Video recording for TRAM, etc.

ACTIA BOP HD-Controller

Redesign

HD-Controller „old“

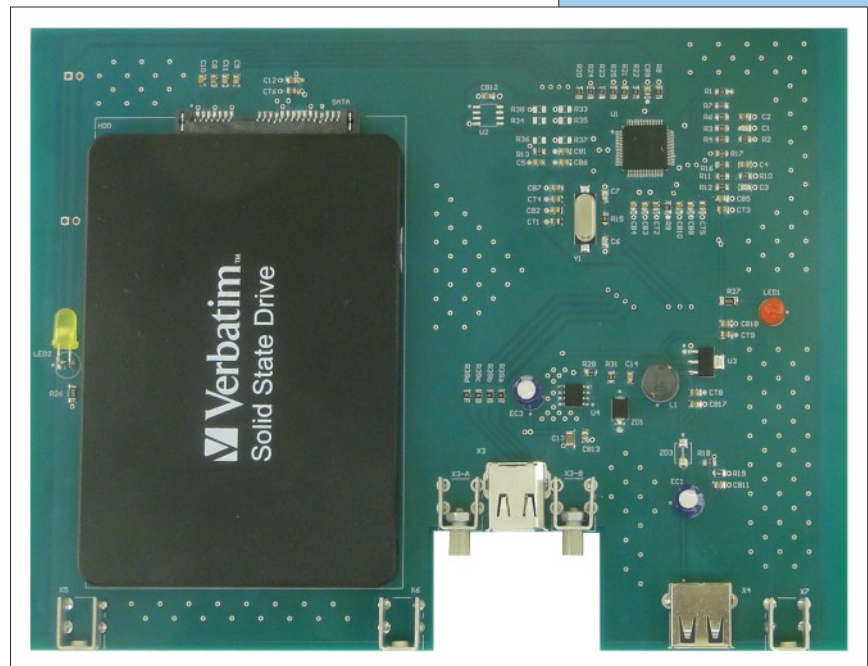
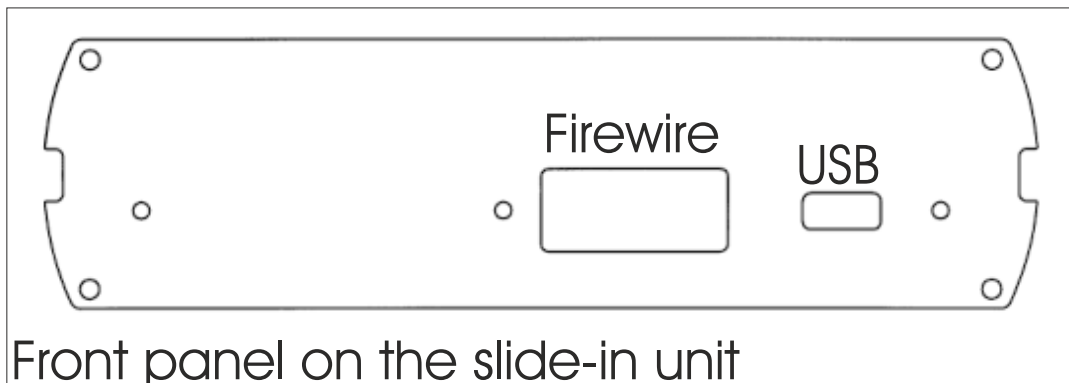
The original HD controllers of the video recording devices from the manufacturer ACTIA, for TRAM and buses, are no longer available. The key components, SATA host adapters JMB 353 from the manufacturer JMicron, are obsolete.

The fully plug-and-play compatible redesign replaces the obsolete original assembly, as the complete device with interfaces, connectors and front panel in the BOB video protection system is replaced.

The plug-in unit also replaces the front panel in the original BOB housing and Firewire and USB connections are in the same place.
